# SERVICE BULLETIN

No. 737

Subject: Elevator Outboard Hinge Installation Inspection

Model Affected: PA-31P Pressurized Navajo  
Serial Numbers Affected: 31P-3 through 31P-7730012

THREE PIECE HINGE INSTALLATION  
Left Elevator Shown - Right Opposite

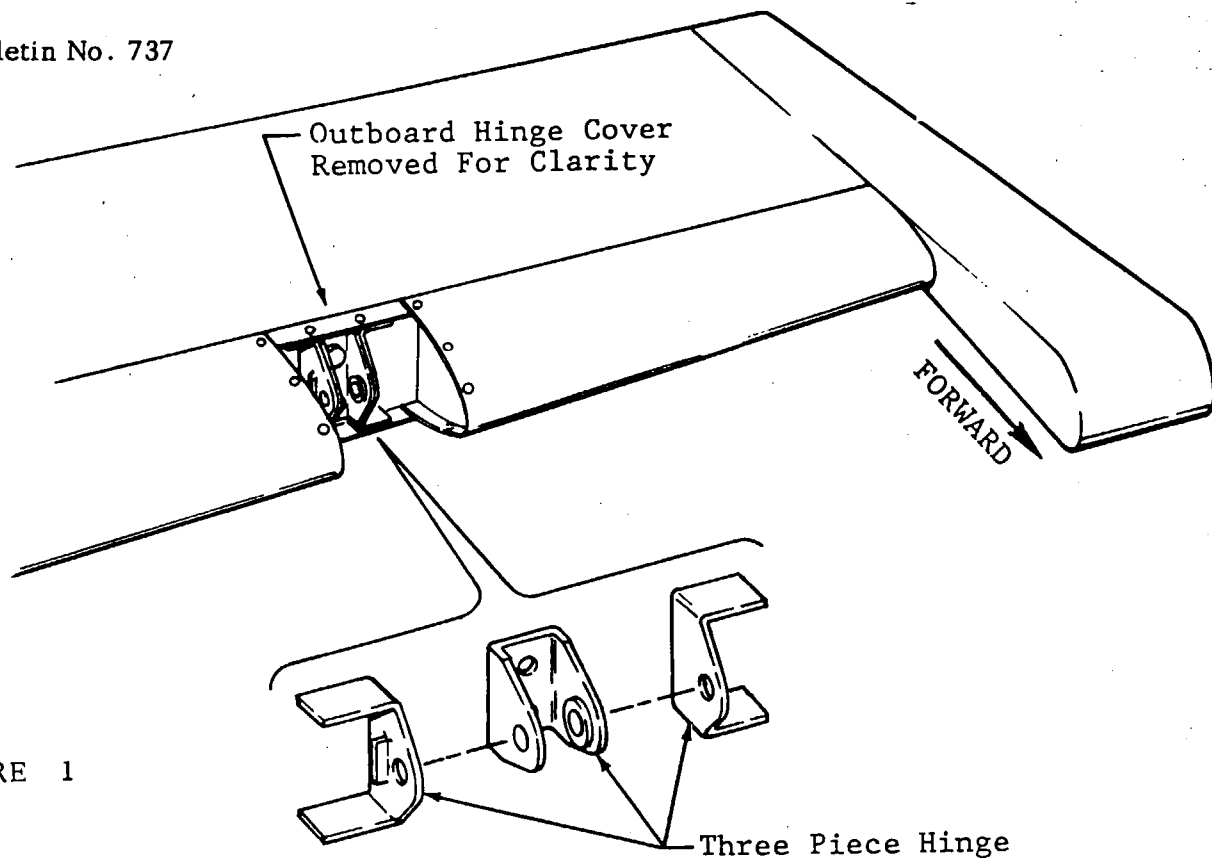
1. Remove the outboard hinge covers from both elevators.
2. Refer to the attached Sketch to determine the type of hinges installed.
  - a. If three-piece hinge installations (Figure 1) are installed, reinstall hinge covers and proceed to Instruction 3.
  - b. If single-piece hinge installations (Figure 2) are installed, Outboard Elevator Hinge Replacement Kit 764 381 must be installed before further flight.
3. Make appropriate logbook entry of compliance.

Material Required: If required by Instruction 2.b., above, one (1) each per aircraft Outboard Elevator Hinge Replacement Kit, Piper Part Number 764 381.
